Office Action Summary	Application No. 10/813,084	Applicant(s) GHONEIMA ET AL.	
	Examiner Howard L. Williams	Art Unit 2819

Claims 19-21 are rejected under 35 U.S.C. 102(e) as anticipated by Lin Li et al.

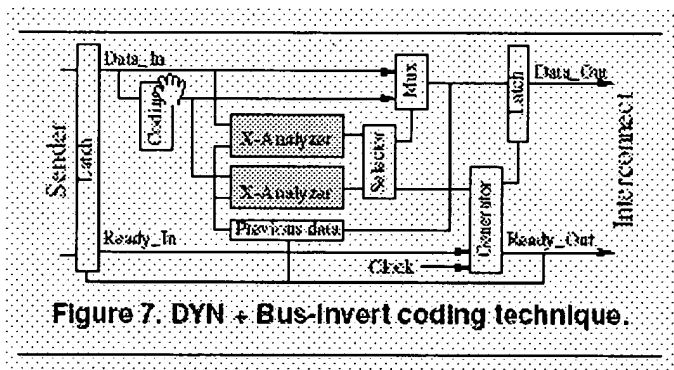
Li discloses in figure 7 a DYN + Bus Invert technique which either passes the data unchanged or selects the coding block via the mux for bus invert coding. Memory element for the input data is read upon the first latch (left side of figure 7) and flip-flops for delay insertion as the second set of latches coupled to the mux output. The “DYN”

or dynamic portion of the technique is described on page 2 left hand column first bullet where the method of analyzing the data to determine dynamically the number of clock cycles for transmission.
